INVITATION TO TENDER NO. PS20200336
CONTRACTOR FOR RAYCAM COMMUNITY CENTRE PLAYGROUND REPLACEMENT

ADDENDUM NO.3

RE: REVISED DRAWINGS (Please refer to them as the most current version)

Attached are the drawings that reflect changes to the following:

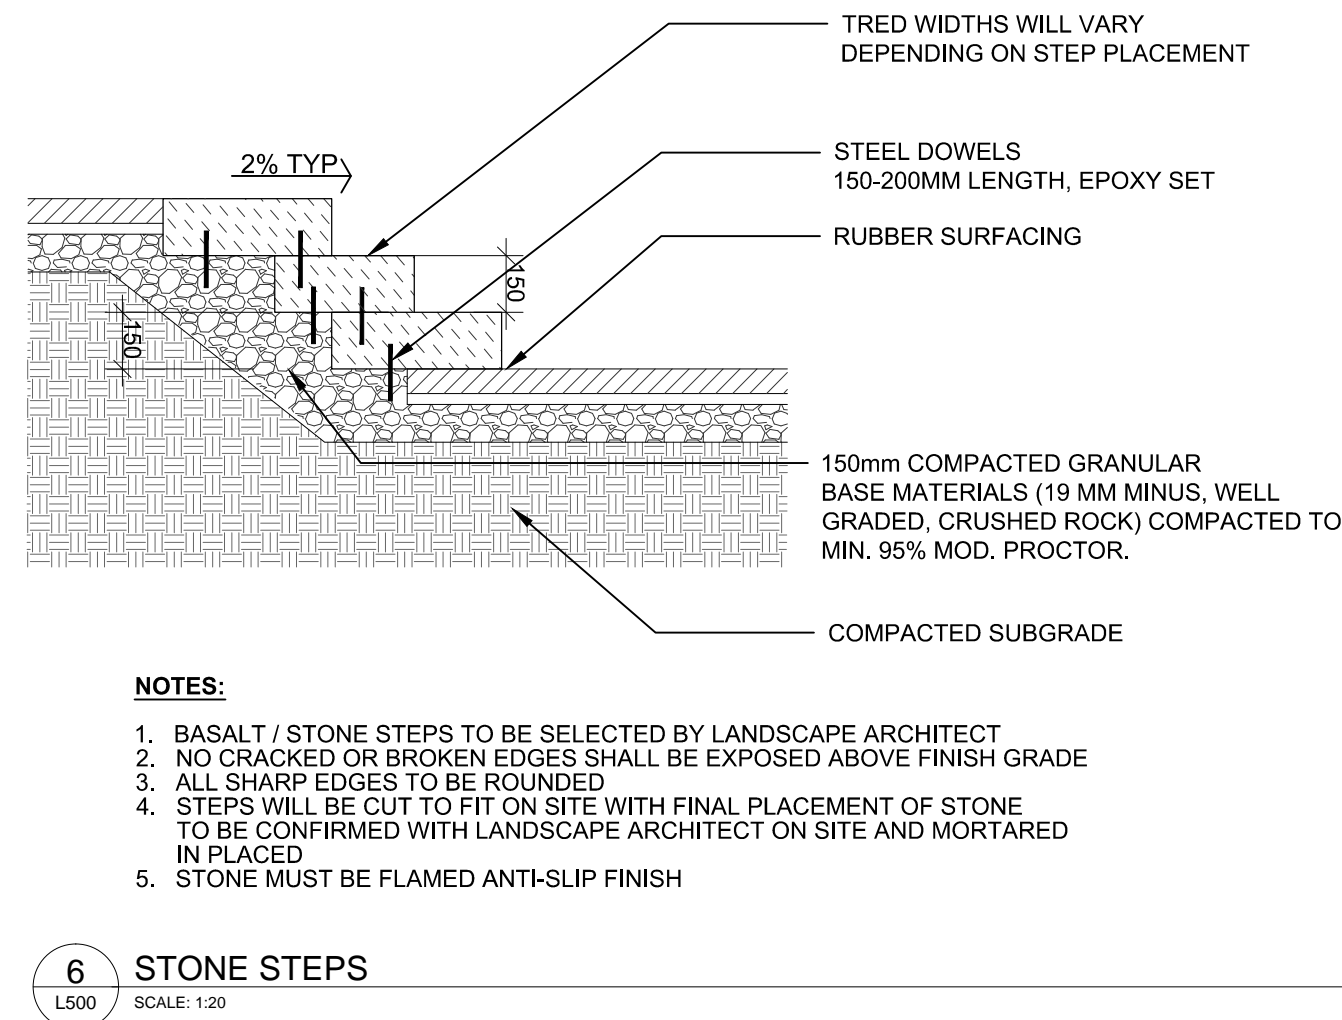
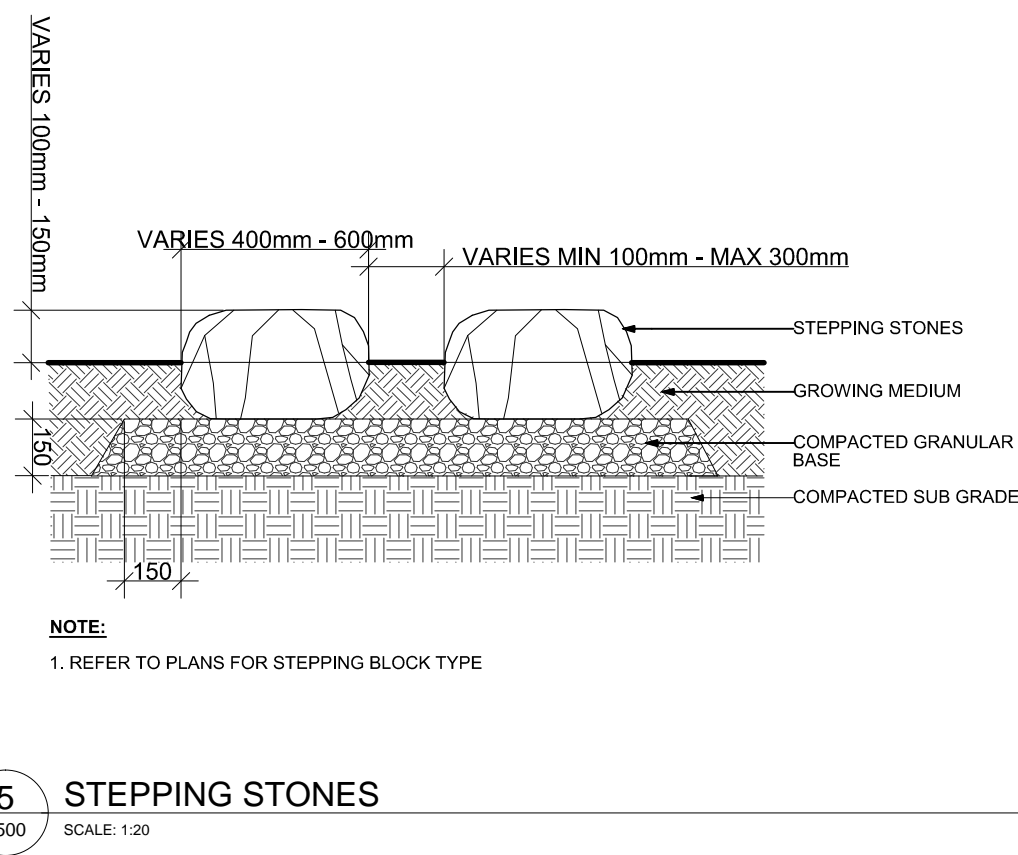
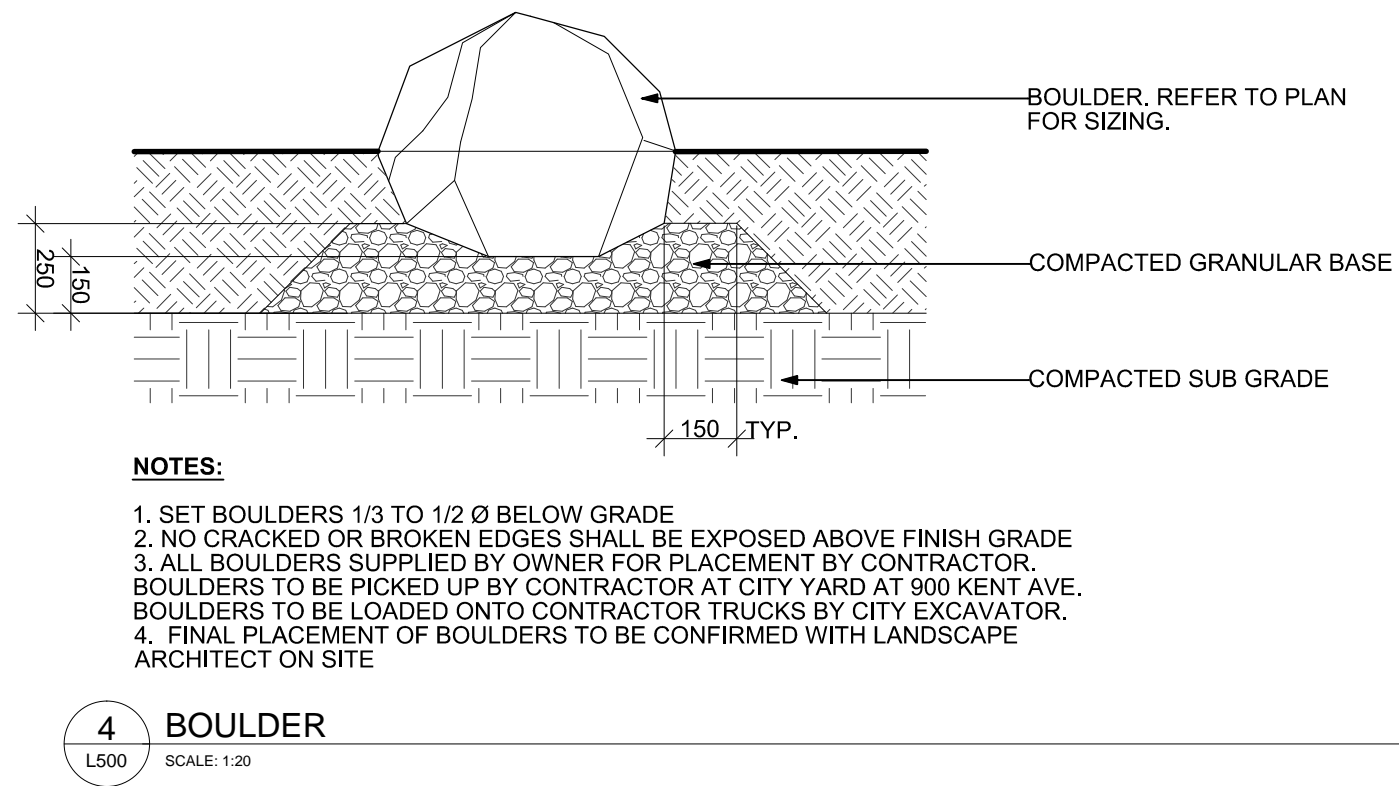
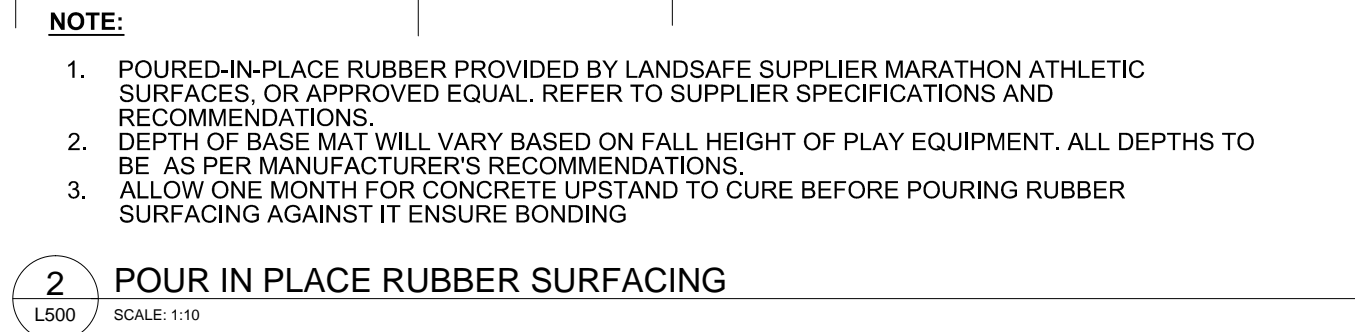
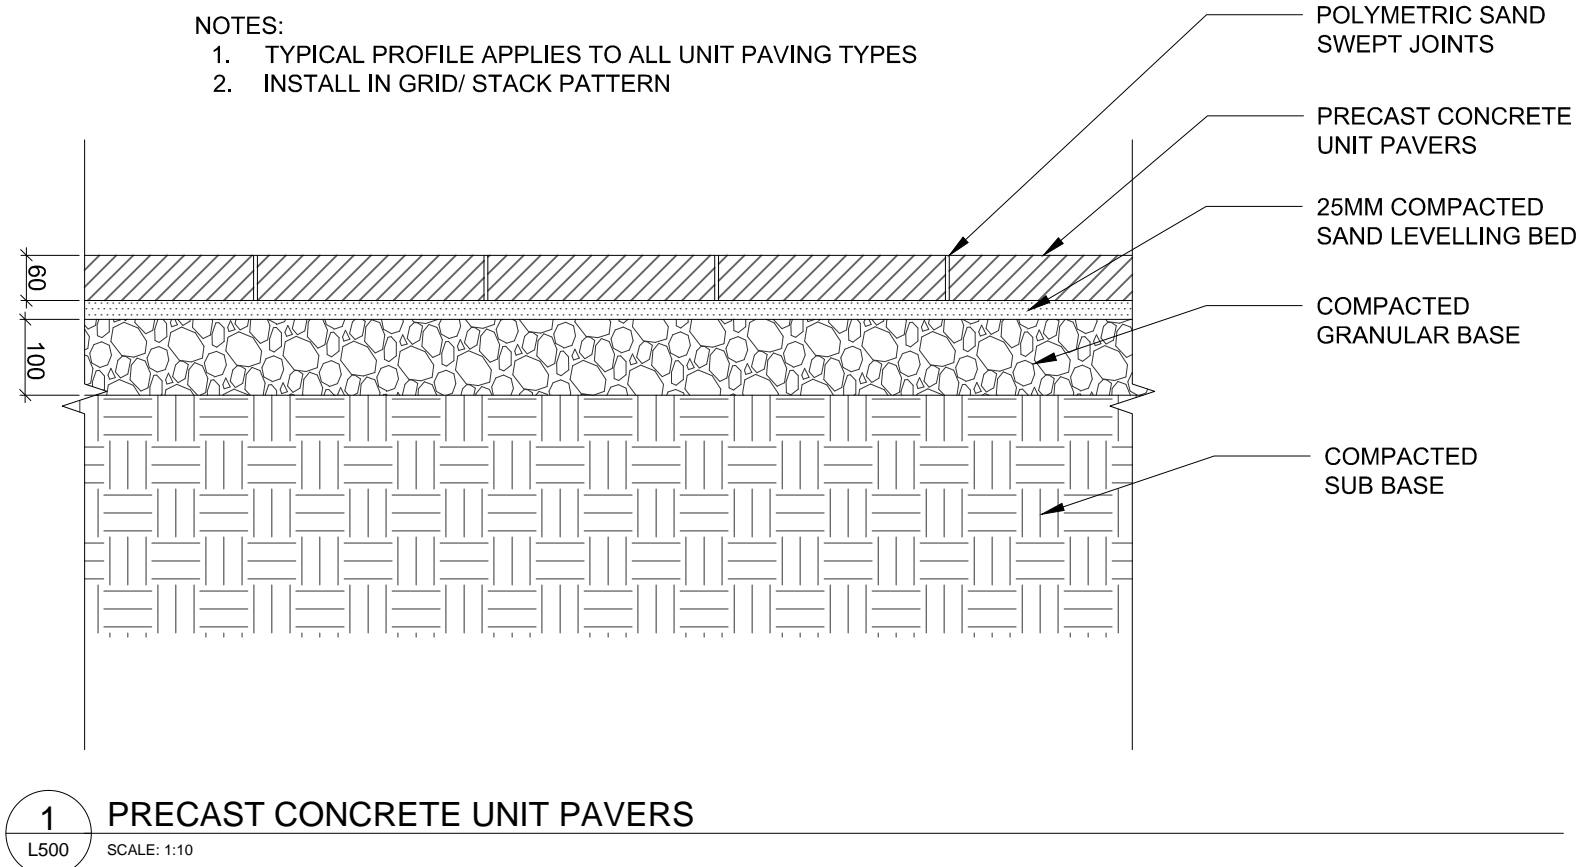
- L-500:
 - Revised detail 2/500: Deleted concrete curb. Shows rubber surfacing against the concrete upstand (for custom wood screen)
 - Revised detail 3/500: Deleted concrete curb. Shows the wood edger underneath the synthetic turf. Transition of turf and rubber surfacing to be seamless.
- L-200:
 - Previous M3 key revised to M4 with a clarified description and detail
- L-203:
 - New drawing separating the lighting as requested. This addendum must be completed, and attached to your Application form.
